SLR Ref No.: 860.016676.00001-L01-V1.1_20260320.docx

RE: Bendigo Ophir Project
Air Quality Assessment Review

Table 1: ORC Information Requests, PDP and SLR Responses

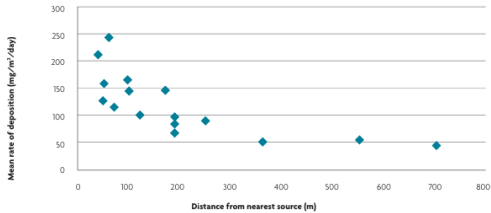
5	<p>Please provide justification for the use of 7.5 m/s wind speeds in the qualitative assessment of dust impacts, when 5.5 m/s is recommended by IAQM (2016) Method or < 5 m/s is discussed in the MfE Good Practice Guide for Assessing and Managing Dust. Your answer should include discussion on mechanically generated dust from vehicle activity (rather than from only wind-blown dust) and should also explain why PDP</p>	<p>PDP considers that the AQA adequately assesses the actual and potential adverse effects of dust, including that generated by vehicle movements. The AQA applies IAQM's Source-Pathway-Receptor framework to assess dust risks, including consideration of local meteorology and receptor distances.</p> <p>IAQM (2016) does not prescribe operational triggers; professional judgement is expected to determine site-specific wind-speed trigger levels. The 5.5 m/s wind-speed figure quoted by SLR Review is only described by the IAQM guidance as 'sometimes used as a general threshold' and states that instead of this general threshold 'it is preferable to use a wind blow initiation wind speed specific to the mineral type.'</p>	<p>The AQA stated that the GPG Dust "suggest that high-risk conditions occur when wind speeds are over 7.5 m/s". The GPG Dust never mentions this wind speed. Further in Section 7.2 the 7.5 m/s is introduced as high-risk conditions for dust generation ("dust pick up begins..."). Then in Section 7.3.4 the high wind speed travel distances are mismatched in the text stating 7.5 m/s in the second dot point (at the top of page 52) whilst presenting 10 m/s in Figure 17. Further Figure 17 compares travel distance rather than dust generation speeds).</p>

#	ORC Request	PDP Response	SLR Response
	<p>only consider high-risk winds of greater than 7.5 m/s are capable of affecting Dwelling 3.</p>	<p>Section 7.3.4 of the AQA utilises Stoke's Law of particle dynamics to estimate that wind-speeds of 5 m/s may transport dust particles (specific to the density of BOGP mine materials) up to 75 m from source, and higher wind-speeds of 7.5 m/s are required to transport these dust particles up to 150 m.</p> <p>Given that the nearest sensitive receptor to dust sources (Dwelling 3) is located approximately 140 m from the BOGP project boundary (and significantly further from construction or operational phase dust sources), only winds greater than 7.5 m/s may present a plausible transport pathway for this receptor given the site-specific density of dust particles.</p> <p>The GPG:Dust also supports site-specific triggers and limiting or ceasing dusty activities on "particularly windy days". The GPG:Dust recommends a wind-speed warning of 10 m/s (1 minute average, occurring twice in 20 minutes) as a suggested trigger level.</p> <p>Section 9.3.2 and Table 23 of the AQMP detail that a two-level trigger alert for 1-hour average wind-speeds will be implemented at BOGP as a dust mitigation measure:</p> <ul style="list-style-type: none"> • Tier 1 trigger (alert to staff for enhanced vigilance of dust): 5 m/s, 1-hour average • Tier 2 trigger (alert to staff to observe dust generating activities and mitigation measures. Cease processes if dust witnessed as crossing the BOGP boundary): 7.5 m/s, 1-hour average. 	<p>For most sources on site this does not impact the assessment, due to the significant distances between sources and receptors. For Dwelling 3, characterised as both an intermediate distance receptor (140 m, Table 33) and a close receptor (100 m, Table 38) in different sections of the AQA, the use of 7.5 m/s has potential implications for the frequency of impacts from the haul road to the entry point of Shepherds Valley (given 53.4% of winds blow in that direction).</p> <p>Rereading the AQA and the PDP response highlights that this receptor should be considered an intermediate distance receptor (140 m). Therefore, putting aside the confusion generated by the multiple designations of the receptor, the use of 7.5 m/s over other published data comes down to professional judgement. Reflecting on PDP's responses and clarification of their position around the purpose of the use of 7.5 m/s, and given the professional experience of the author and reviewers, the use of 7.5 m/s can be accepted in the context as a plausible transport pathway for an intermediate distance receptor.</p> <p>Additionally, SLR has reviewed external data (Bluett et. al. 2015¹) that supports PDP's position based on the likely distance of dust impact from haul roads to receptors. While the data reviewed was from an unfinished study the data supports limited impacts from a haul road.</p>
